SERVICE BULLETIN

N° 139-649

ATA 67 – TAIL ROTOR ACTUATOR UPGRADE

**SERVICE BULLETIN SB_27-0040 TAIL ROTOR ACTUATOR
P/N 3G6730V00731 UPGRADE TO P/N 3G6730V00732**

Figure 1: Dynamic Seals Orientation in the Inboard and Outboard Body (Central Glands)

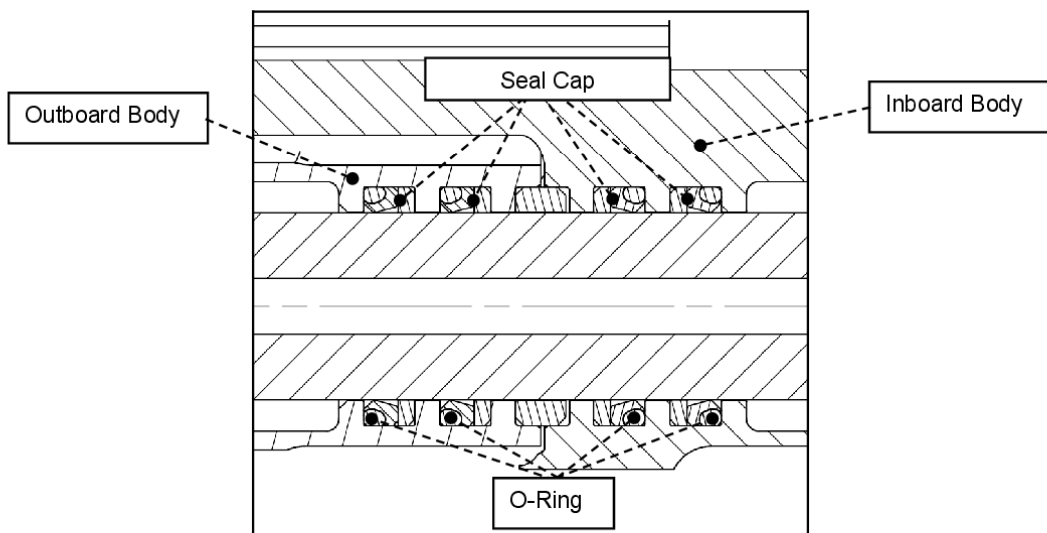
1. Refer to Figure 1. Install the O-Ring (P/N 081341), the Seal Cap and Back-Up Ring (P/N 085366) in the interface bores of the inboard (P/N 71827-81 or 70715-81) and outboard bodies (P/N 70711-81 or 71831-81).

Figure 2: Dynamic Seals Orientation in the Inboard and Outboard Glands

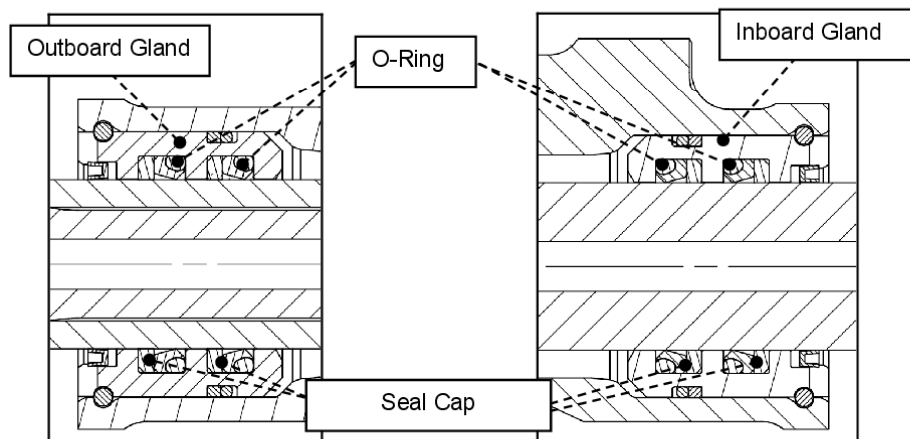
- Refer to Figure. 2. Install the O-Ring P/N 081341, the Seal Cap and Back-Up Ring P/N 085366 and Scraper Ring (P/N R2001-118-S-043) to the internal bores of each of the Outboard and Inboard Glands (P/N 71839-82).

Figure 3: Input Lever disconnected during Valve Matched Assy Synchronization

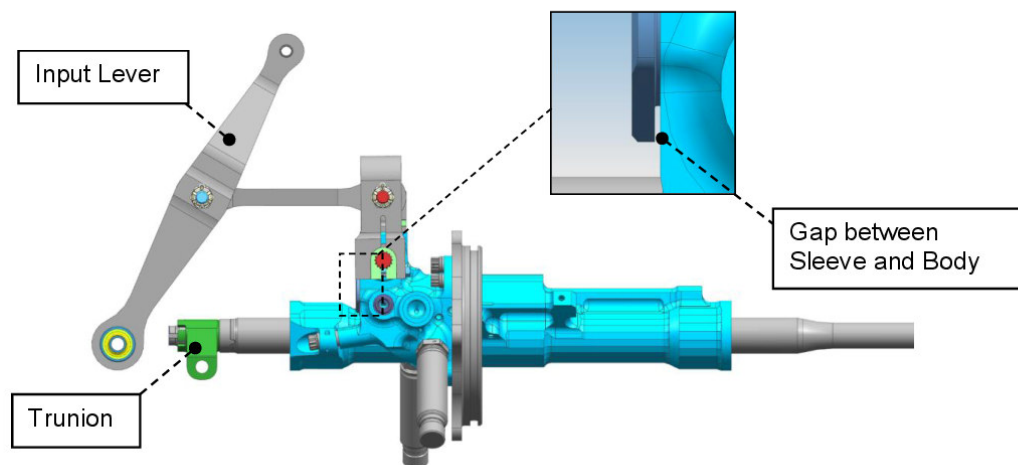
System 1 and System 2 matched valve assemblies shall be synchronized in open loop (Pilot Input Lever P/N 70765-81 and Trunion P/N 70731-84 disconnected. See Figure 3) as per the following procedure:

Figure 3: New identification label

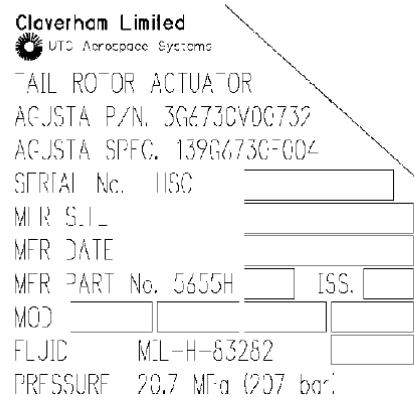
To complete the Service Bulletin, the Identification Label P/N 71123-82 assembled on the Tail Rotor Actuator P/N 5655H1 has to be removed and scrapped.
 The new Identification Label P/N 165410-1 with the appropriate fields filled has to be applied, on the modified Tail Rotor Actuator P/N 5655H2.
 Ensure that the new label is marked with the all the information, e.g. Unit Serial Number, MFR Site, MFR Date, MFR P/N and ISS etc.
 Also record the implemented SB 27-0040, marking the body adjacent to the label with indelible black ink and apply transparent laquer (see Figure 4).
